## UN Regulation No. 131

### Uniform provisions concerning the approval of motor vehicles with regard to the Advanced Emergency Braking System (AEBS) for M<sub>2</sub>, M<sub>3</sub>, N<sub>2</sub> and N<sub>3</sub> vehicles

**Figure 1:**  
**Left turn or right turn at the intersection**

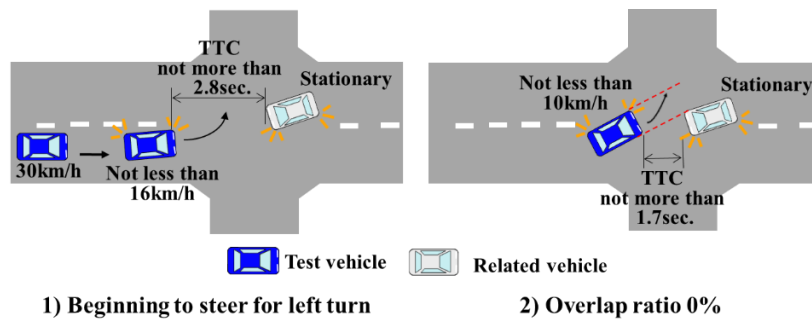
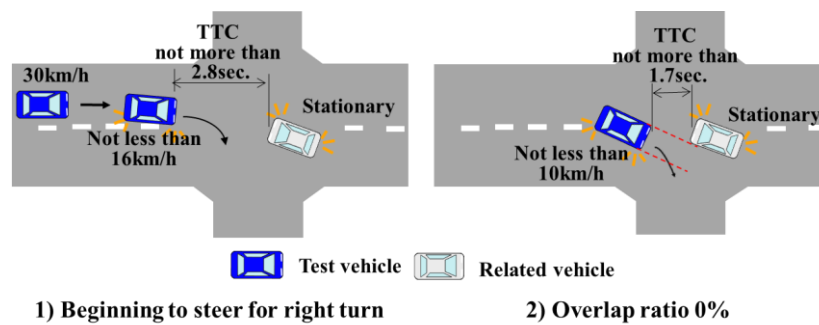
The blue car needs to be changed from passenger vehicle to large vehicle.

**Figure 2:**  
**Right turn or left turn of a forward vehicle**

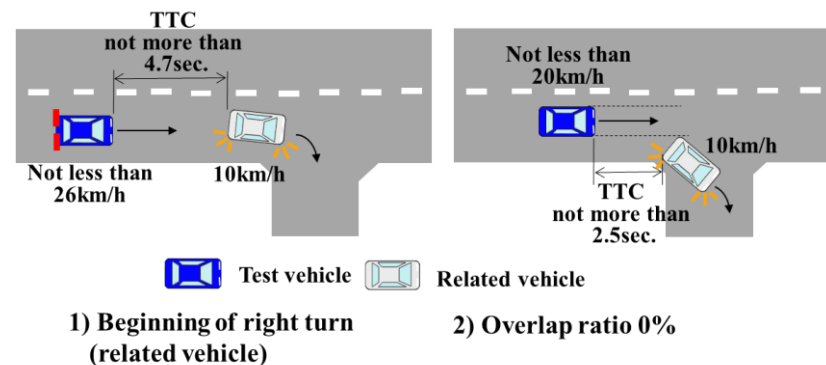
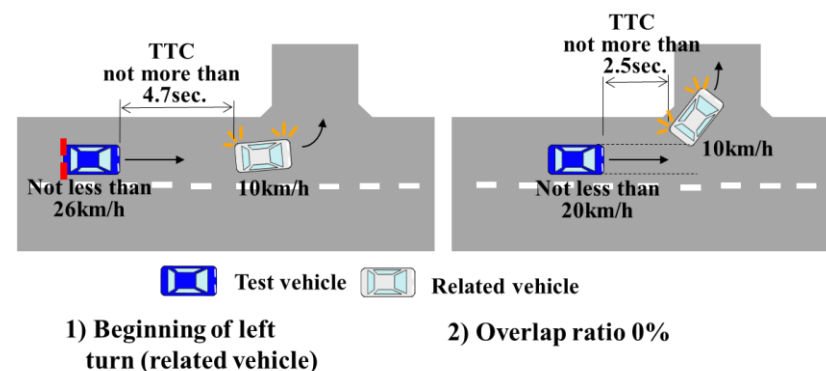
The blue car needs to be changed from passenger vehicle to large vehicle.

**Figure 4:**  
**Lane change due to road construction**

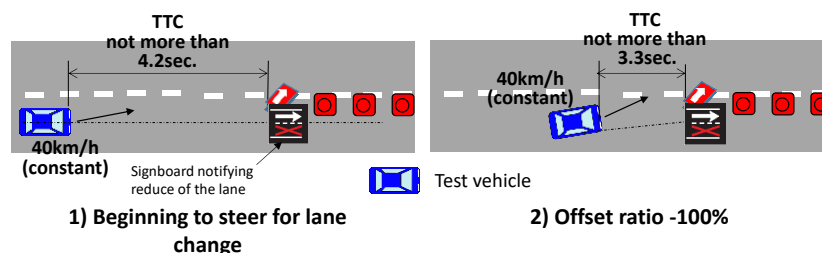
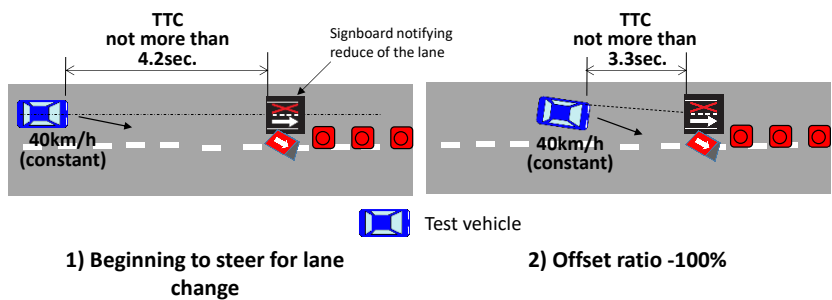
The blue car needs to be changed from passenger vehicle to large vehicle.
